STATE OF NORTH CAROLINA
DEPARTMENT OF TRANSPORTATION

July 8, 2020

Subject: **Request for Modification to the Regional General Permit Number 31, Section 401 Water Quality Certification, and Neuse Buffer Authorization for Improvements to Existing I-440 Beltline, from south of SR 1313 (Walnut Street) to north of SR 1728 (Wade Avenue), Wake County. WBS 35869.1.2. TIP U-2719**

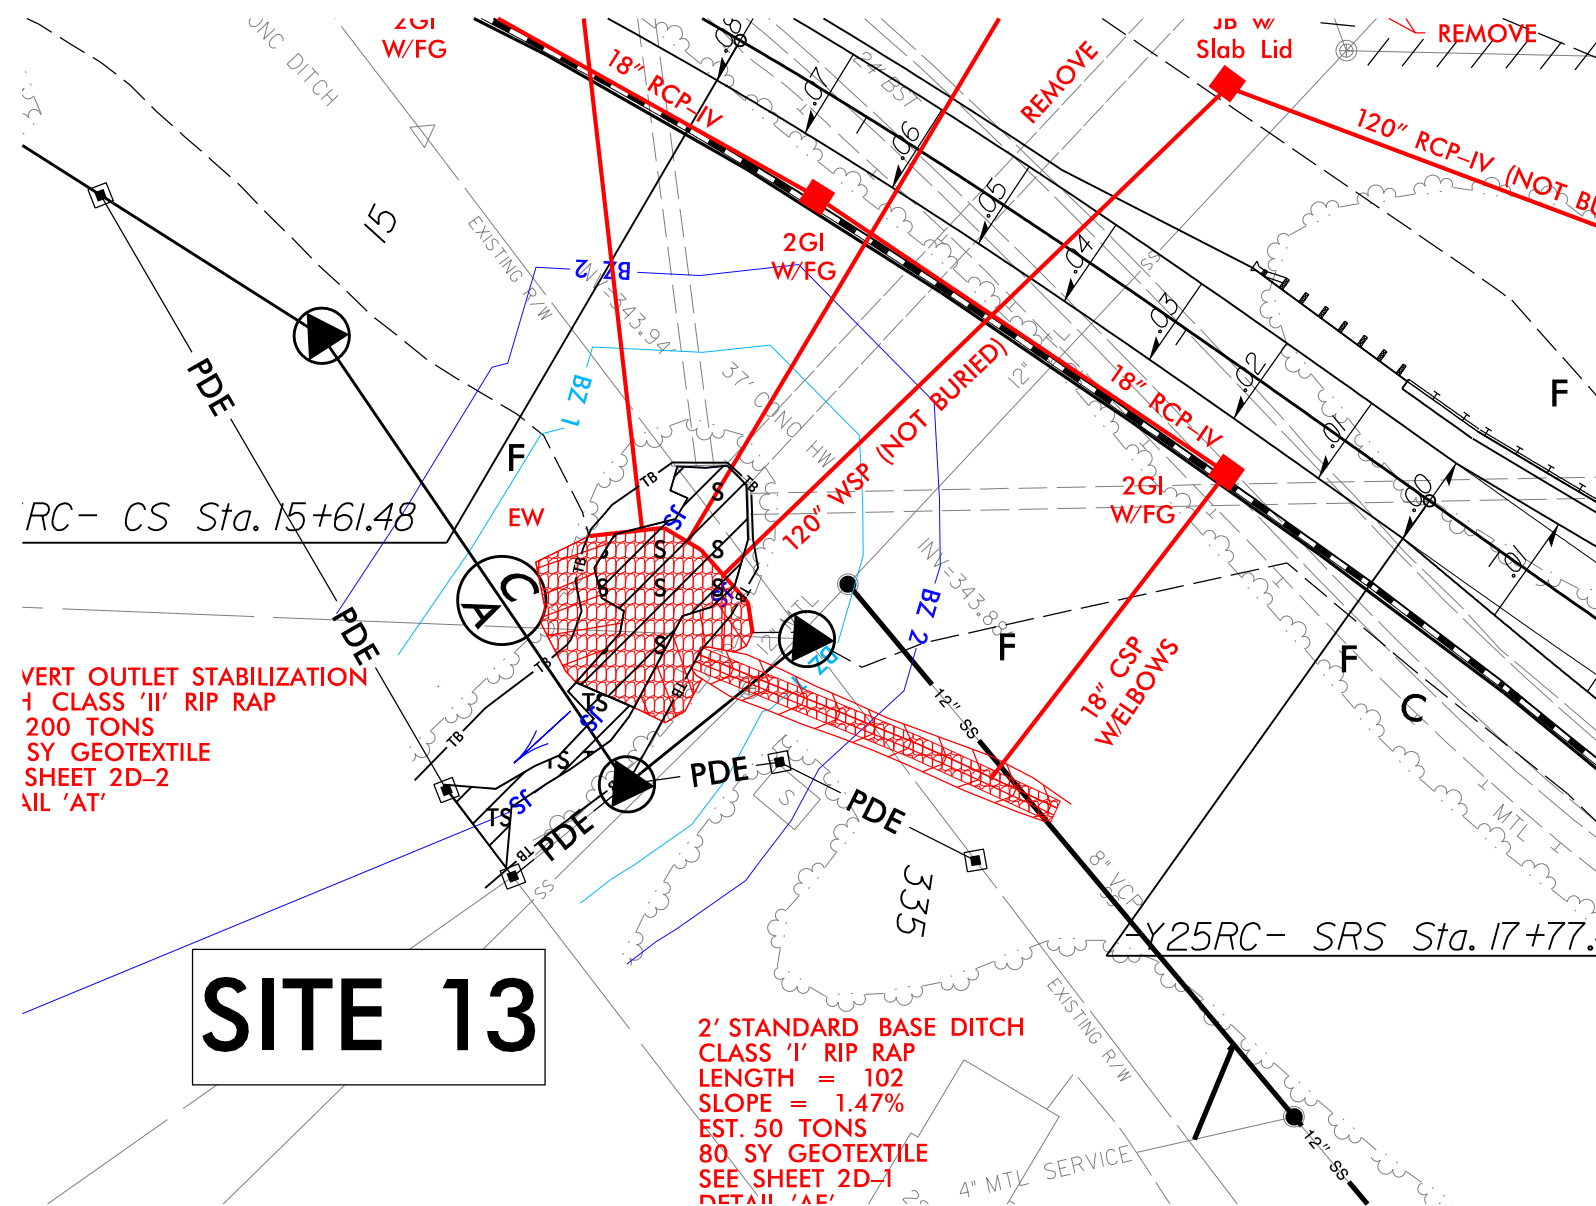
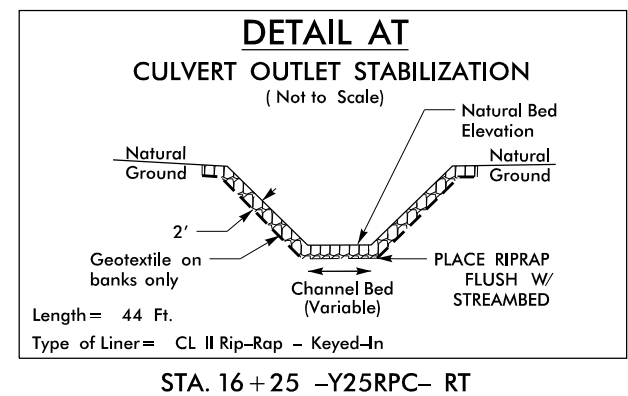
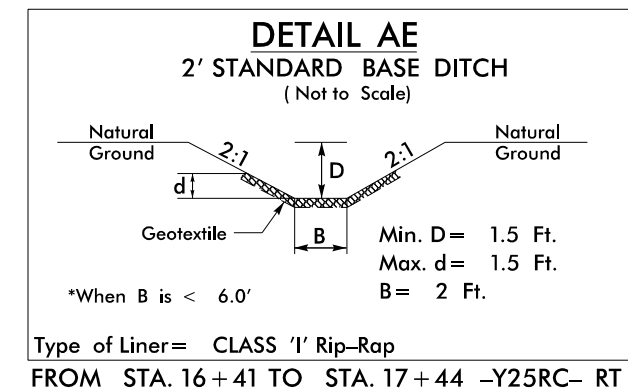
Site 13 (Sheet 17/17B) – Site 13 has a reduction in buffer impacts as a result of changing the PDE for a property owner who wanted to minimize impacts to an existing shed. The decrease in mitigable buffer impacts at Site 13 in Zone 1 is 913 sq ft and 1,569 sq ft in Zone 2. This makes the total allowable impact in Zone 1 7,989 sq ft and Zone 2 is 6,169 sq ft for Site 13.

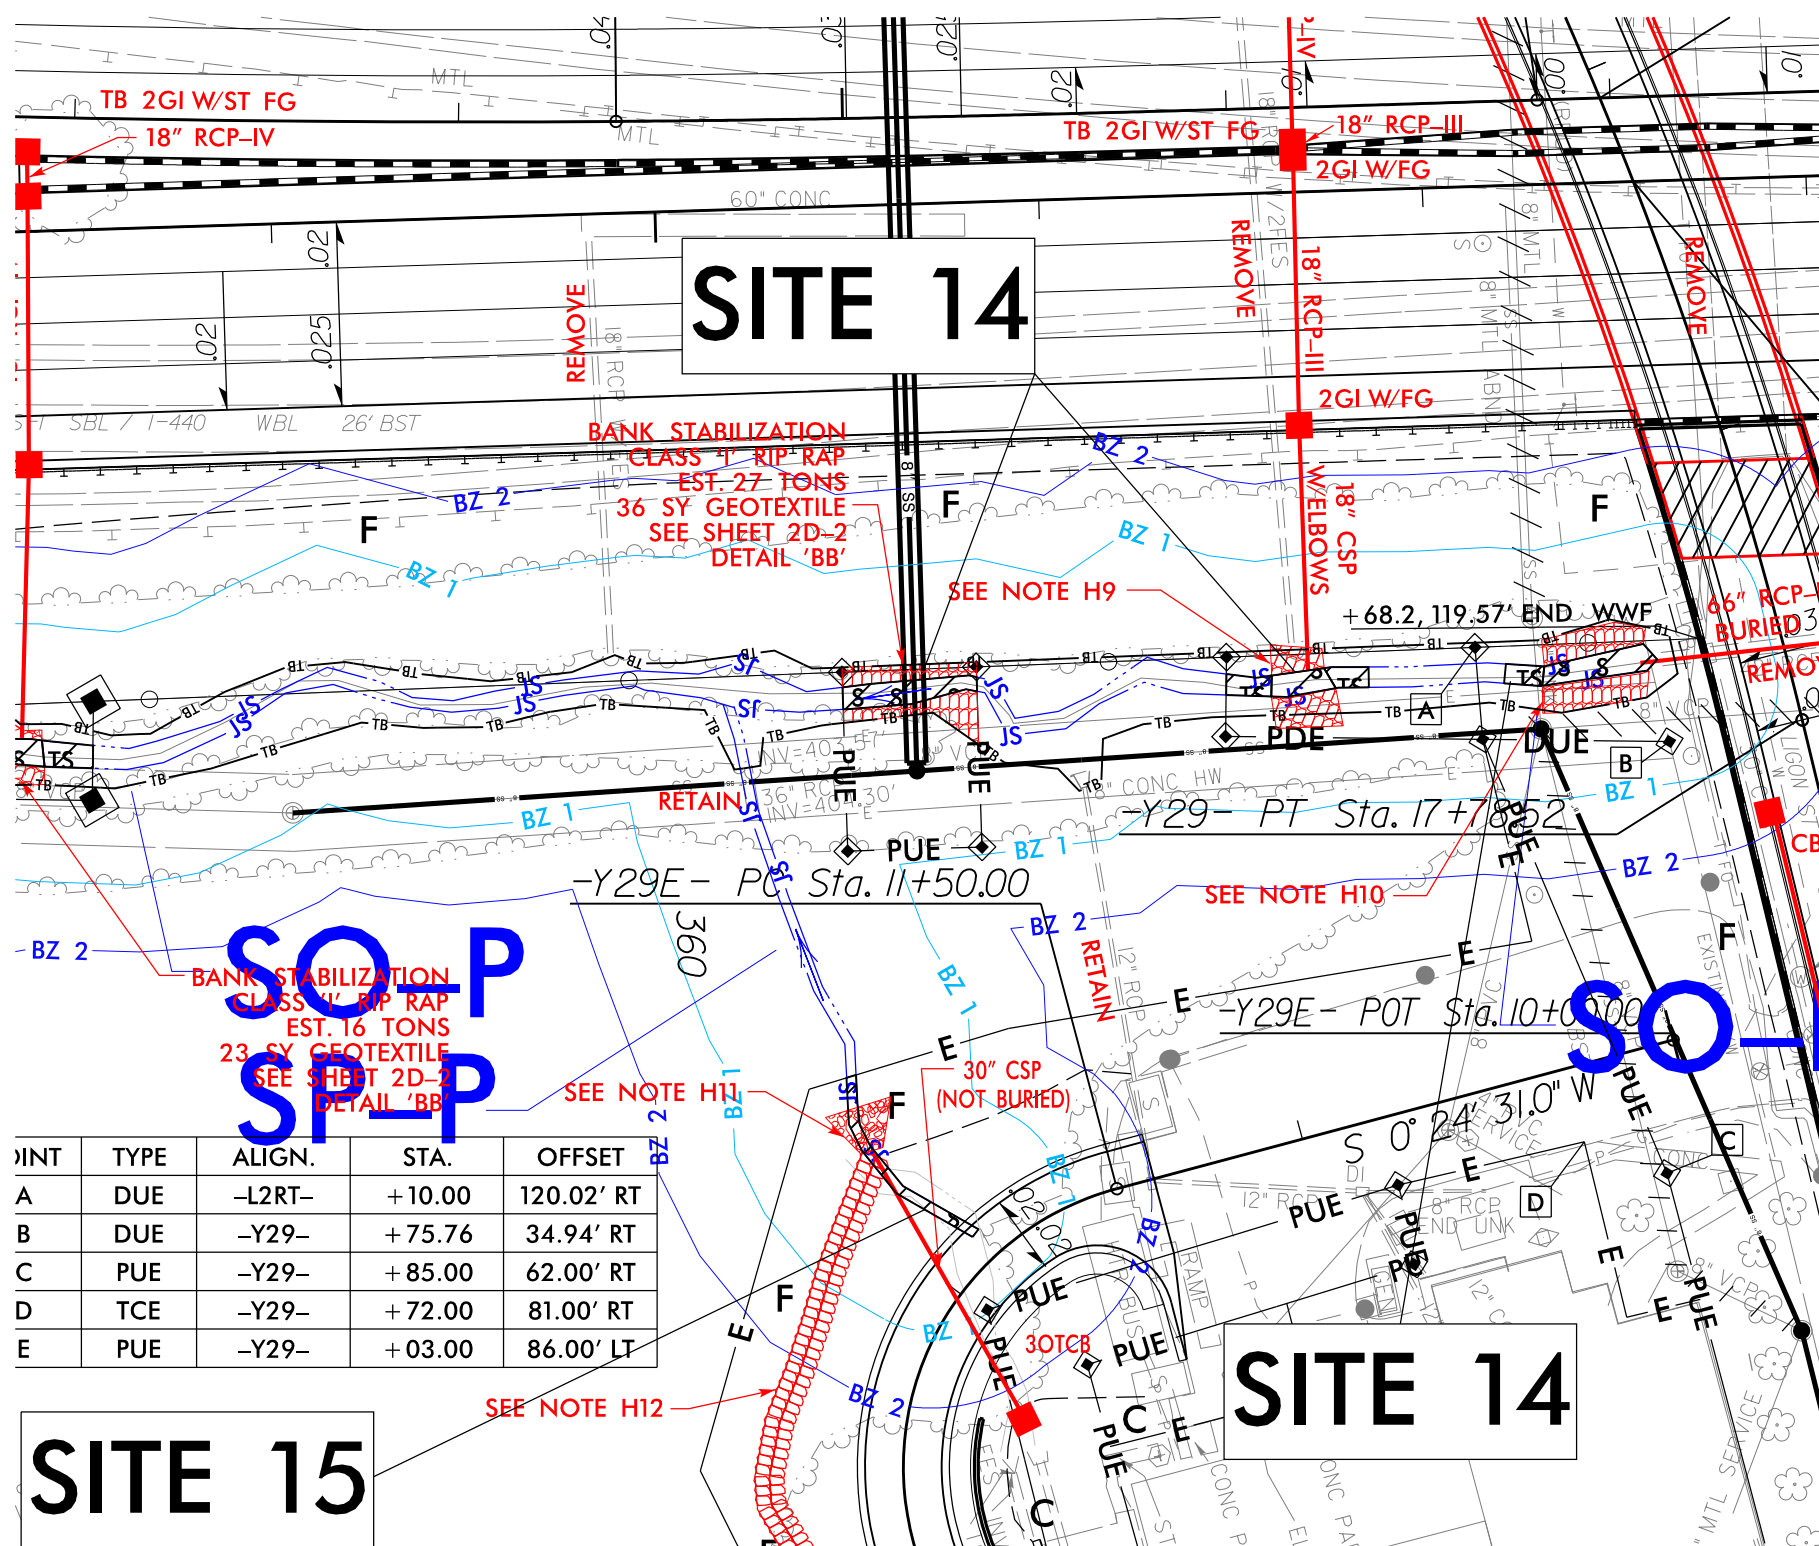
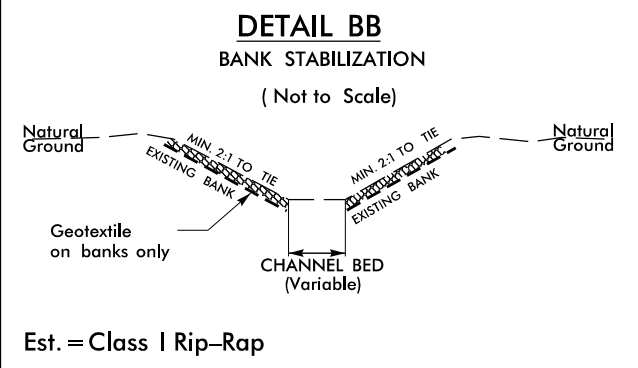
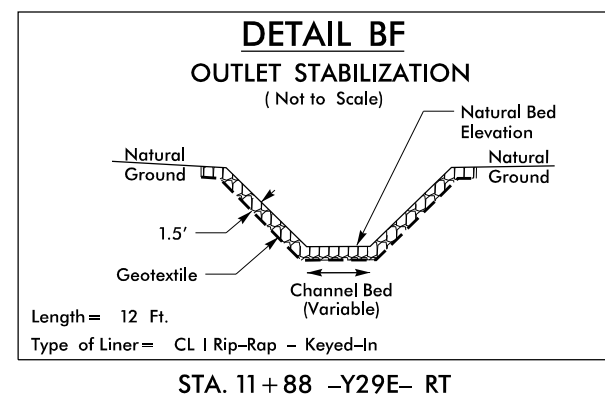
Site 14 (Sheet 18/18A) – Site 14 has an increase in permanent stream impacts and allowable buffer impacts due to a sewer line which will be bored under I-440. The increase in permanent stream impacts is due to bank stabilization being installed according to the utility recommendations. Bank stabilization impacts result in an additional 35 lf of permanent impact. Buffers will also be impacted by installation of the bank stabilization resulting in an additional 4,075 sq ft of impact in Zone 1 and 1,396 sq ft in Zone 2. This makes the total allowable impact in Zone 1 10,921 sq ft and Zone 2 is 2,780 sq ft for Site 14.

Site 15 (Sheet 18/18A) – Site 15 impacts did not change; however, the design has changed and is visible on the revised drawing.

PROJECT REFERENCE NO.		SHEET NO.	
U-2719		28	
RW SHEET NO.			
ROADWAY DESIGN ENGINEER		HYDRAULICS ENGINEER	
DOCUMENT NOT CONSIDERED FINAL UNLESS ALL SIGNATURES COMPLETED  Gradient, PL 1111 127 W. Chatham St., Cary, NC 27611 N.C.B.E.L.S. License Number: P-1875  25 12.5 0 25 50 Feet

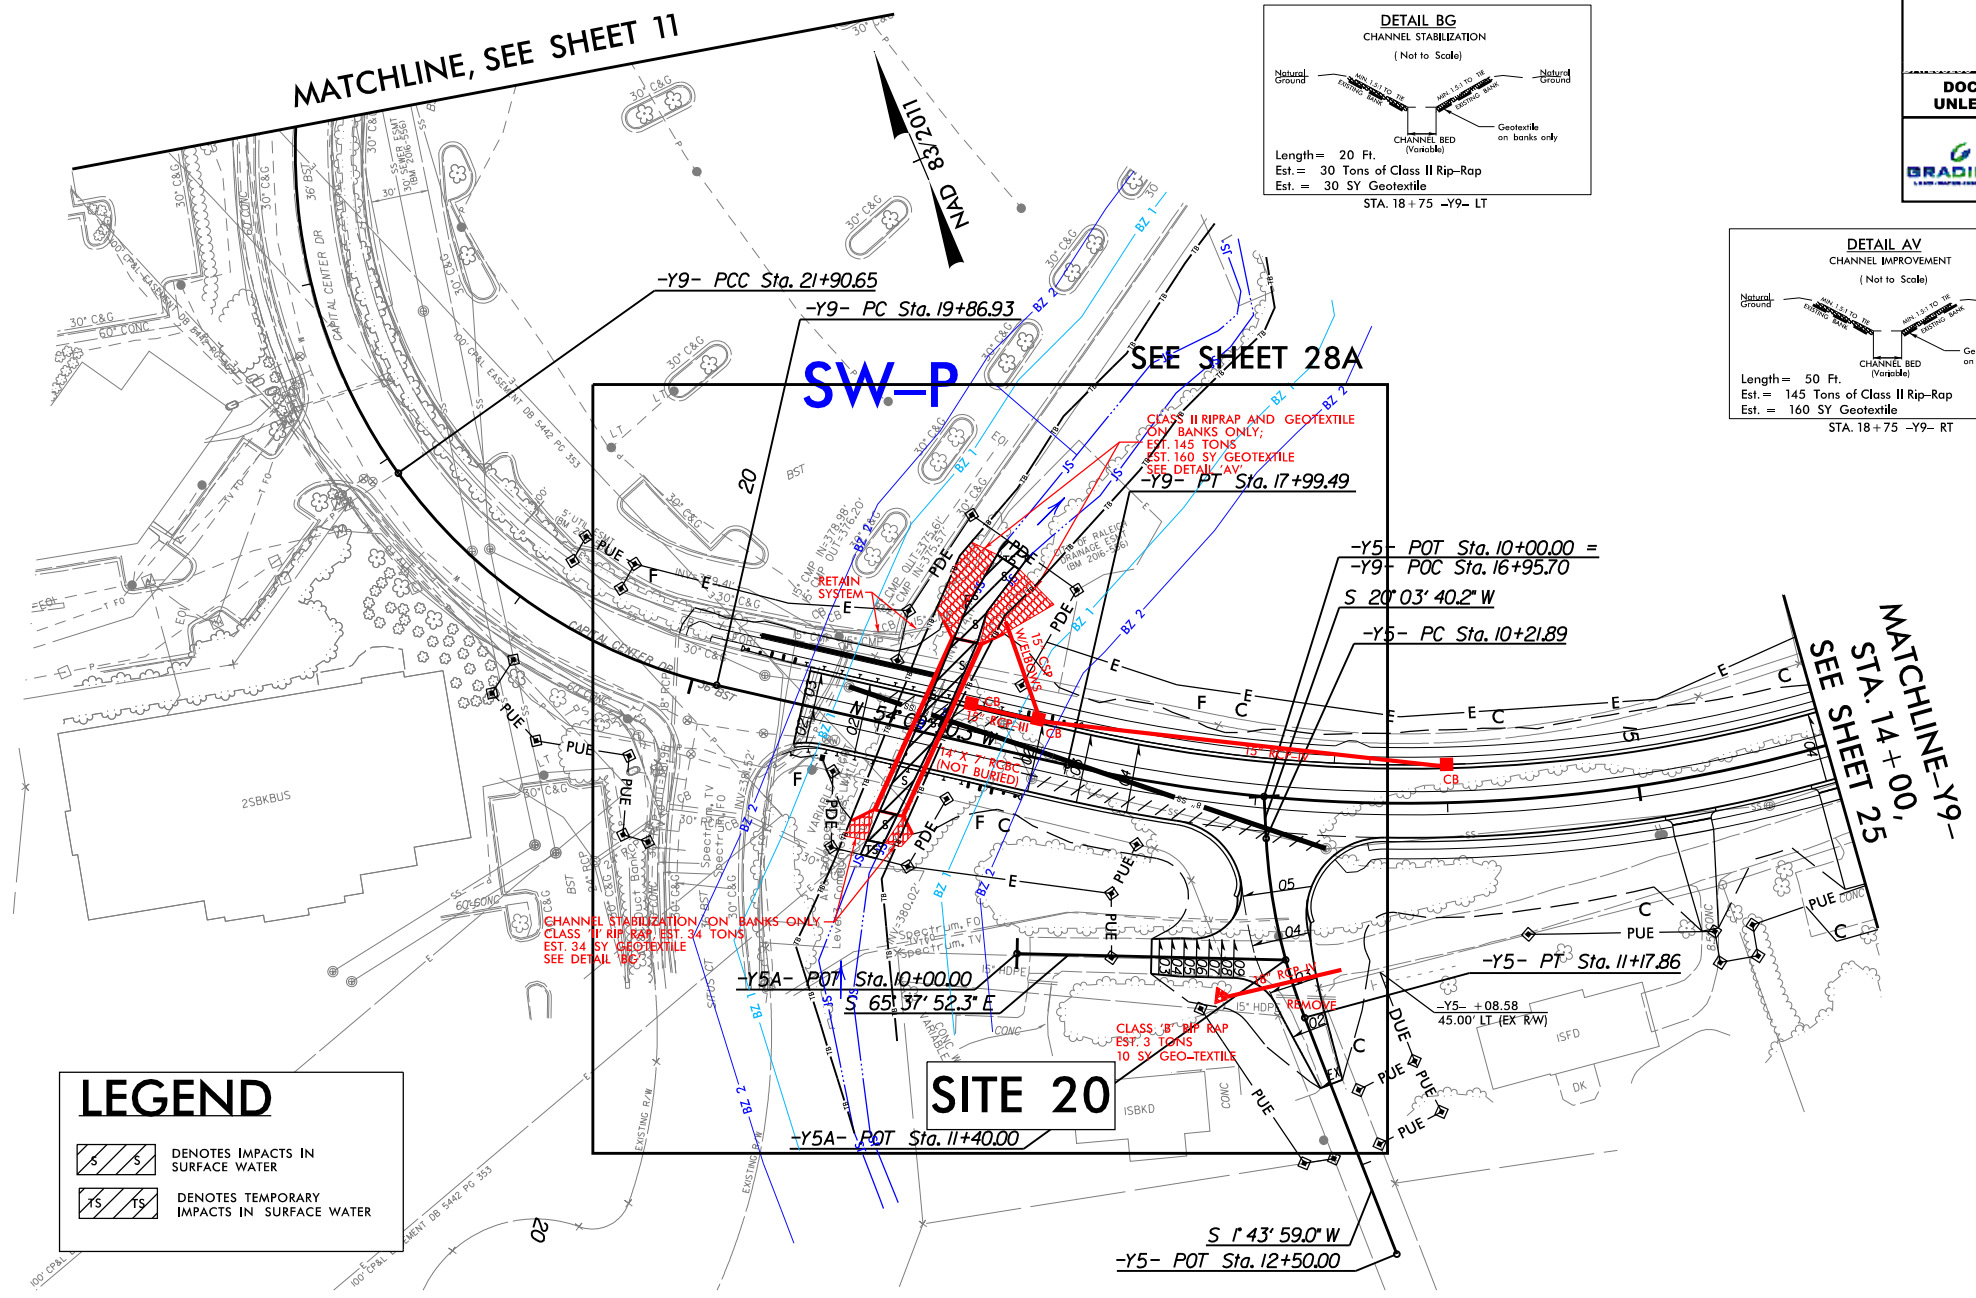
Site 20 (Sheet 28) – Site 20 impacts changed as a result of the final design of the 14'x7' RCBC in which the culvert length was increased slightly from preliminary plans and a shift in the PDE and easement due to utilities and constructability needs. The culvert length resulted an increase in permanent impacts by 6 lf for the RCBC and by 15 lf for bank stabilization. The temporary impact at this site was reduced by 11 lf. There will be a total of 98 lf of impact due to the RCBC, 65 lf of bank stabilization, and 18 lf of temporary stream impact at Site 20.
